ADDENDUM NO. 1

Ozark Correctional Center-Replace Floor & Equipment, Food Service Building
Ozark Correctional Center
Fordland, MO
Project No.: C2237-01

REPLACEMENT OF FLOOR
AND FOOD SERVICE
EQUIPMENT

ADD-01

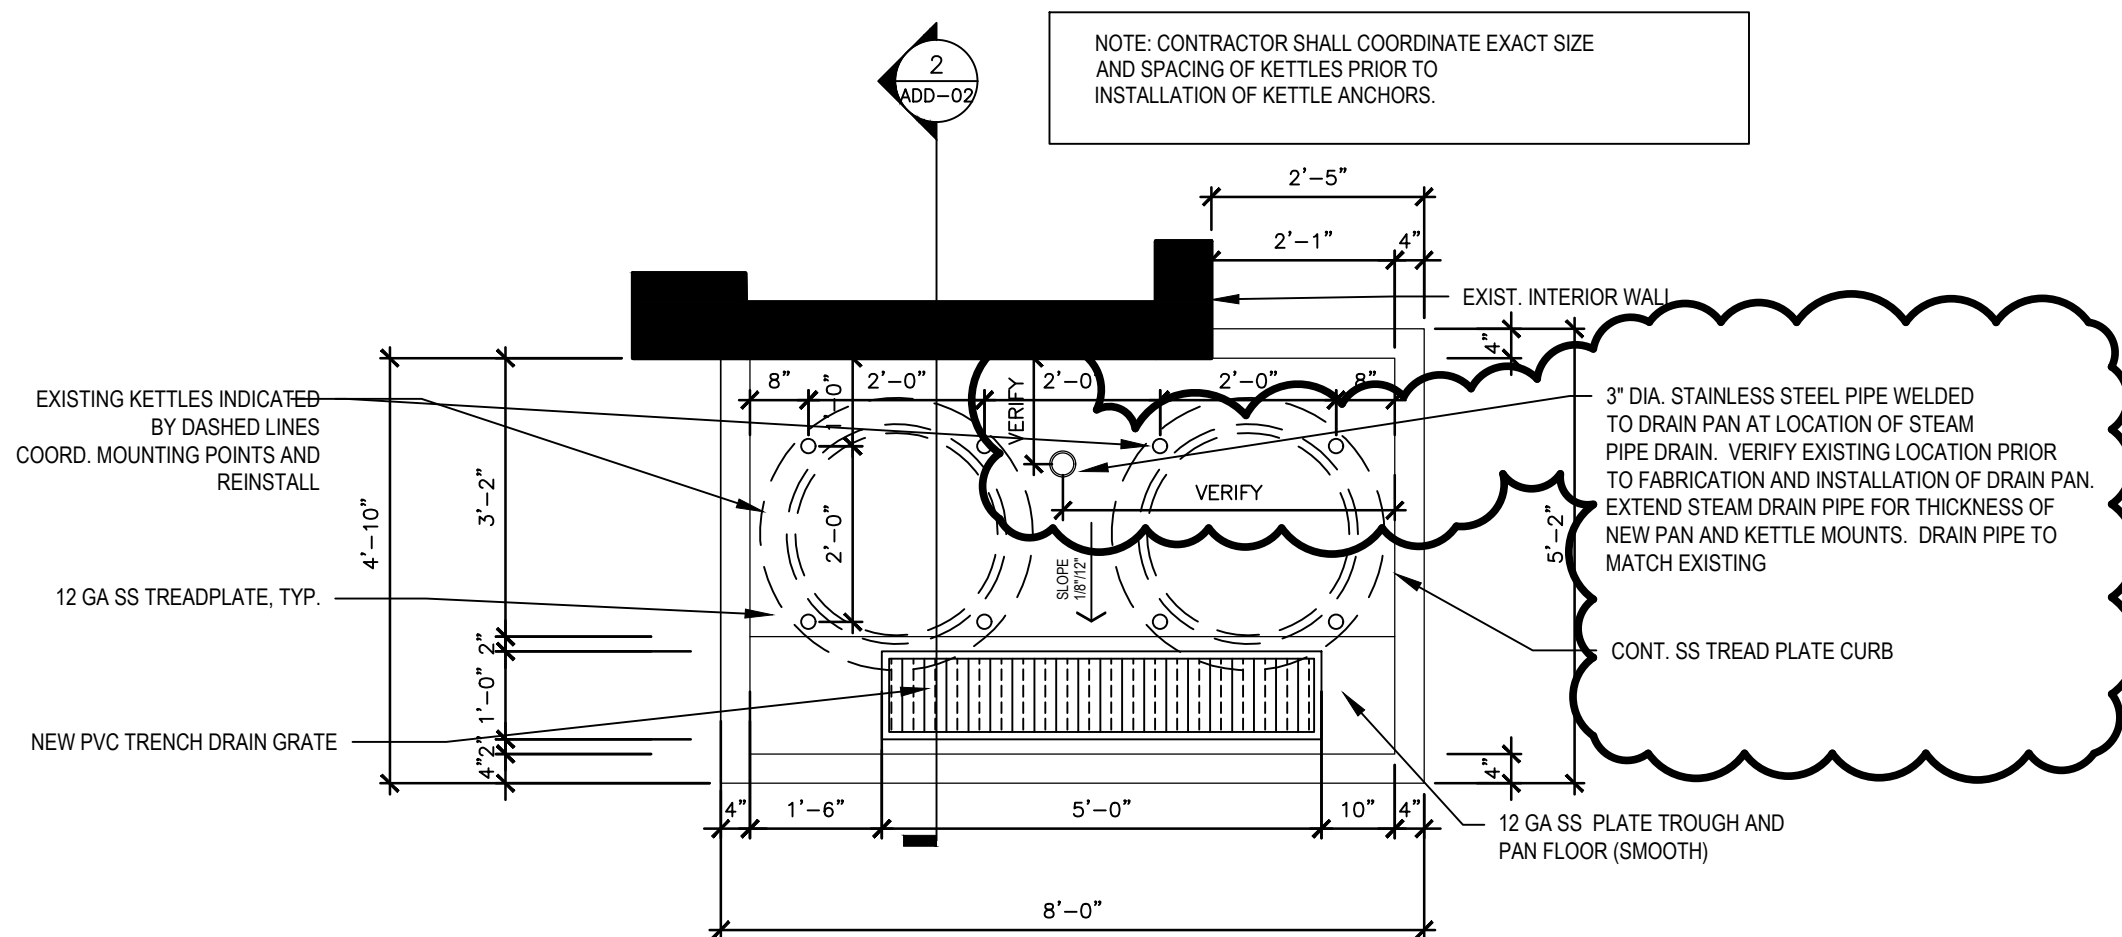
1. Sheet ME-101
 - a. REVISE Note 8 to read “FLOOR: **6 INCH THICK WITH SMOOTH ALUMINUM (10 GA) WALKING SURFACE ADHERED TO 1/2" OSB BOARD FOAMED IN PANEL, STRUCTURAL FLOOR WITH FRP BEAMS AND REINFORCED EXTERIOR BOTTOM**”
2. Sheet A-501
 - a. ADD note “3" DIA. STAINLESS STEEL PIPE WELDED TO DRAIN PAN AT LOCATION OF STEAM PIPE DRAIN. VERIFY EXISTING LOCATION PRIOR TO FABRICATION AND INSTALLATION OF DRAIN PAN. EXTEND STEAM DRAIN PIPE FOR THICKNESS OF NEW PAN AND KETTLE MOUNTS. DRAIN PIPE TO MATCH EXISTING”
 - i. Refer to attached sheets ADD-01 and ADD-02
